## 12 Cressy Road, NW3 2LY

Design, Access & Heritage Statement for Ground Floor Side Extension. Addendum. **New Heat Pump, Combined Intake-Exhaust Grille for MVHR System & Rear Elevation Materials Changes.**

Client	Mr + Mrs Monteiro
Presentation	Planning
Date	September 2022
File	CSY-3-03-RT-0002 Rev A
Page	2 of 6

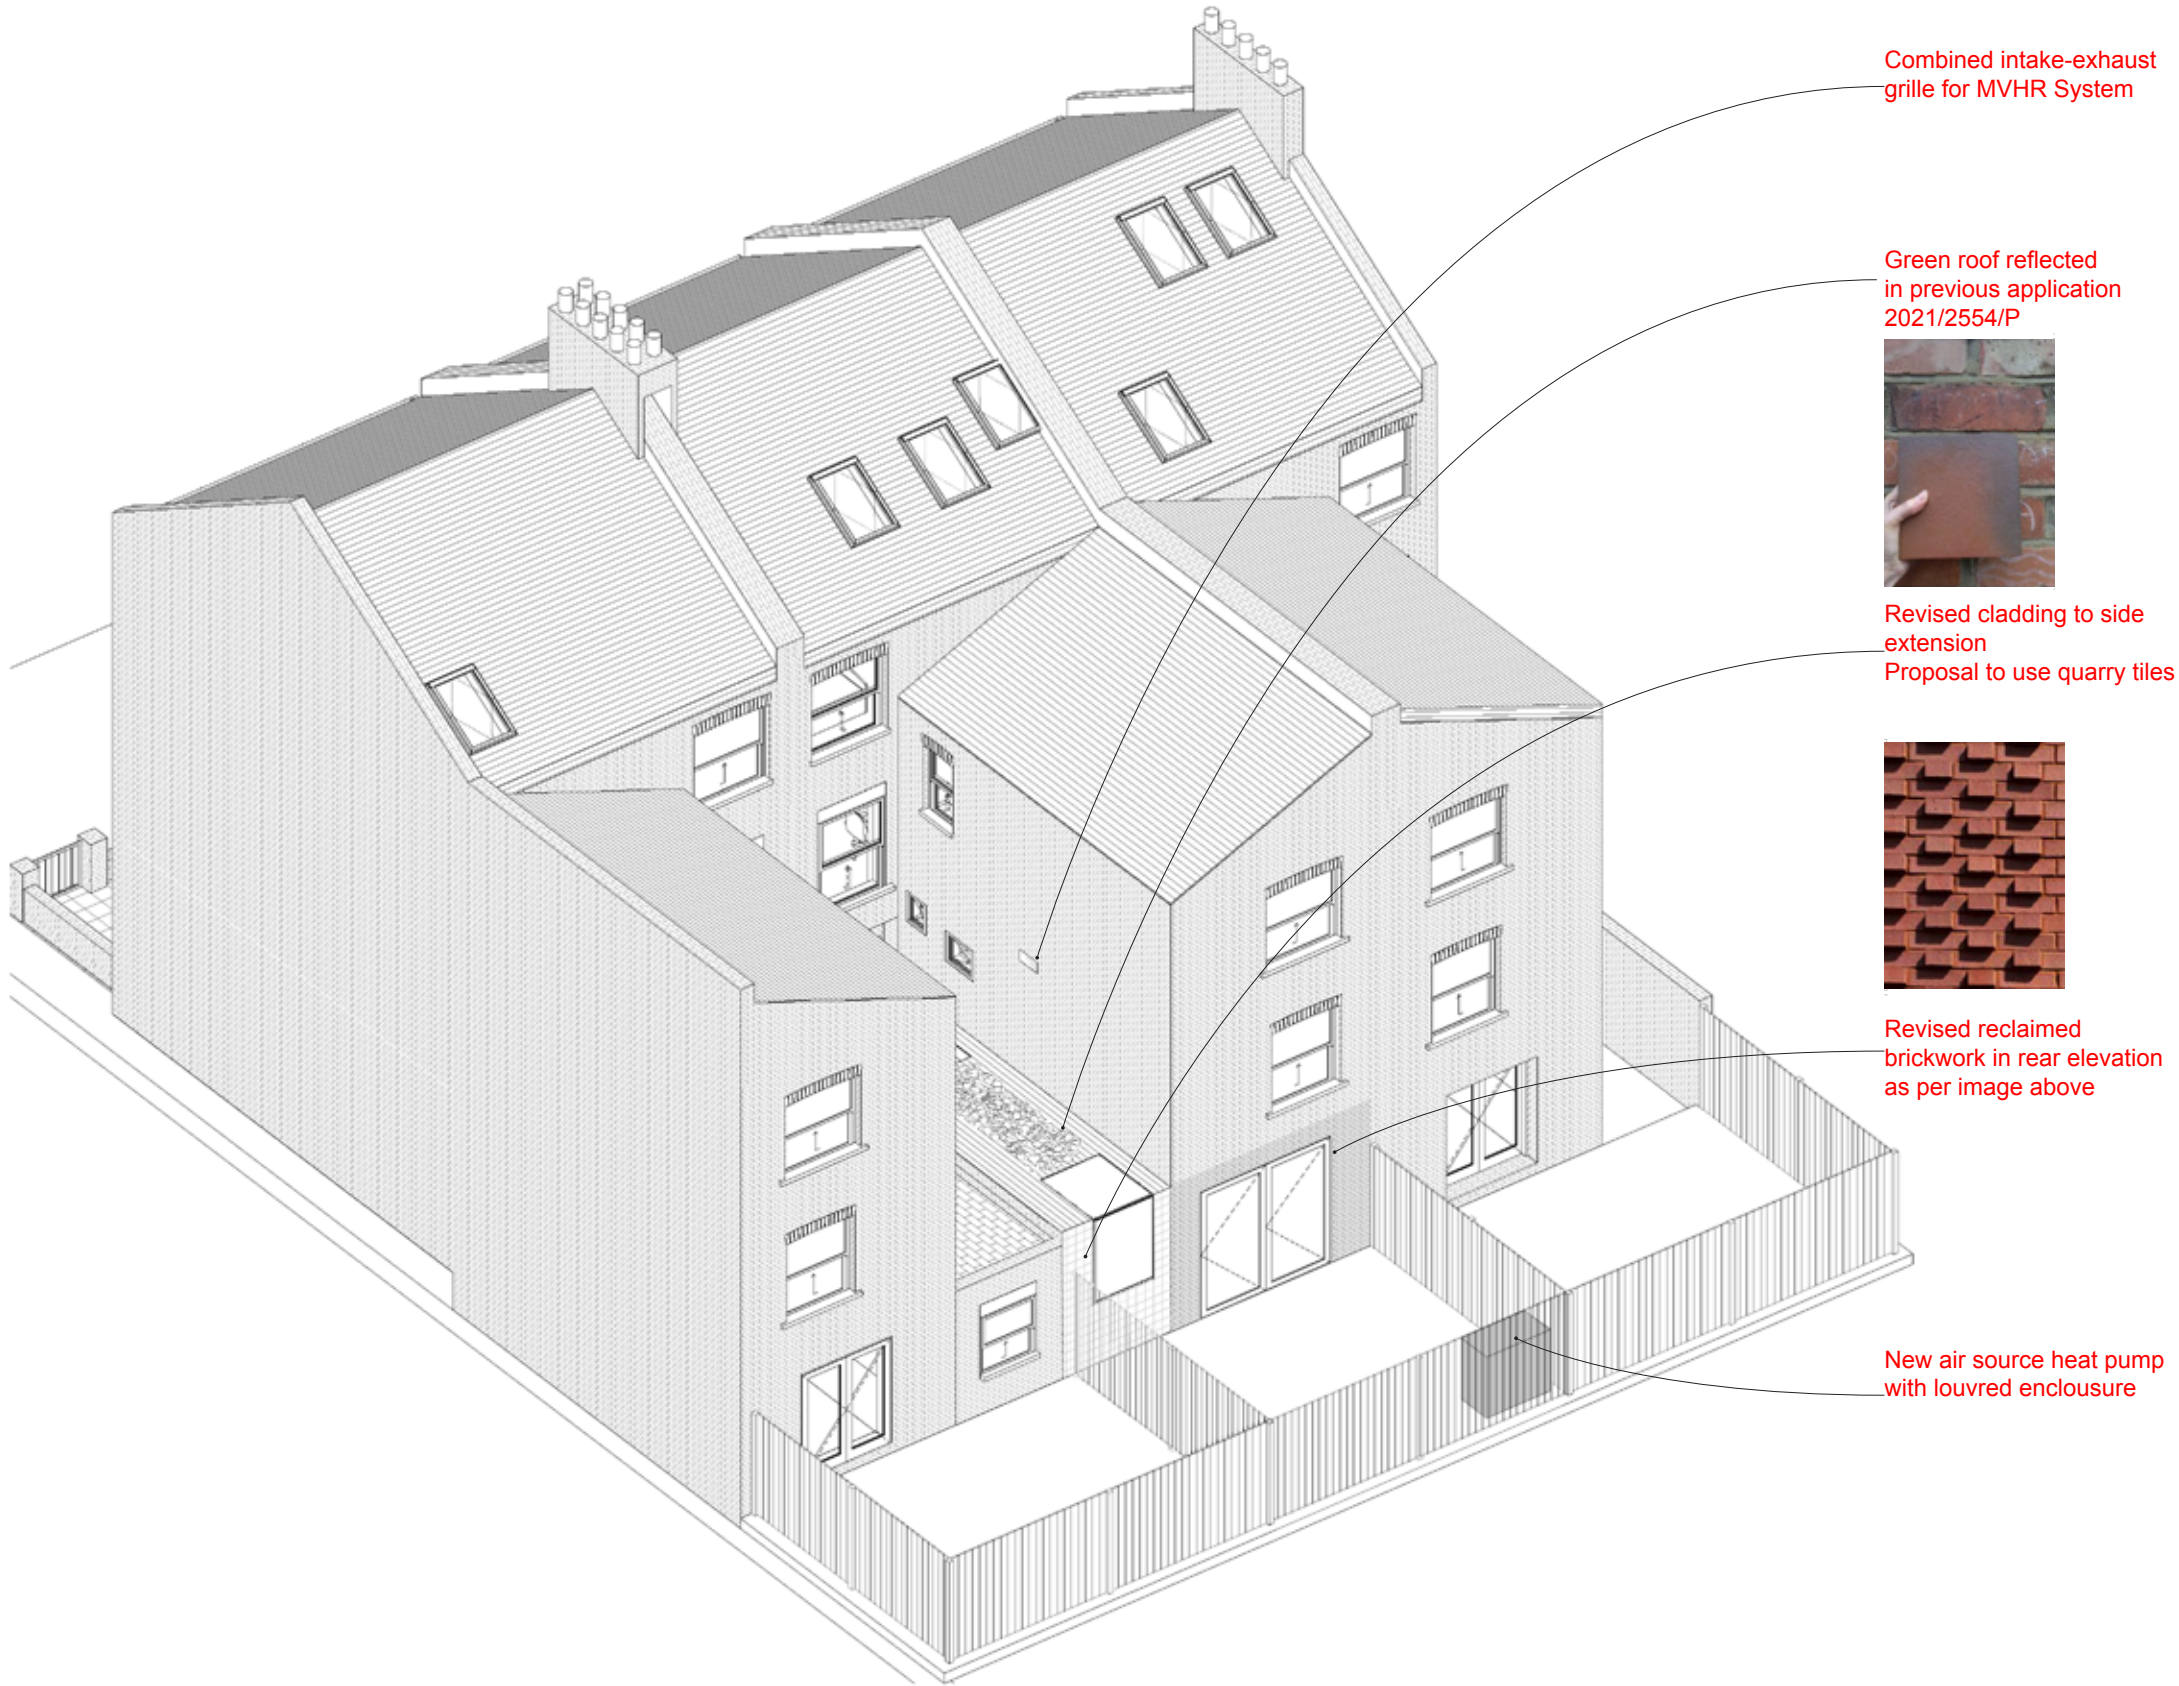
Combined intake-exhaust grille for MVHR System

Green roof reflected in previous application 2021/2554/P

Revised cladding to side extension  
Proposal to use quarry tiles

Revised reclaimed brickwork in rear elevation as per image above

New air source heat pump with louvred enclosure
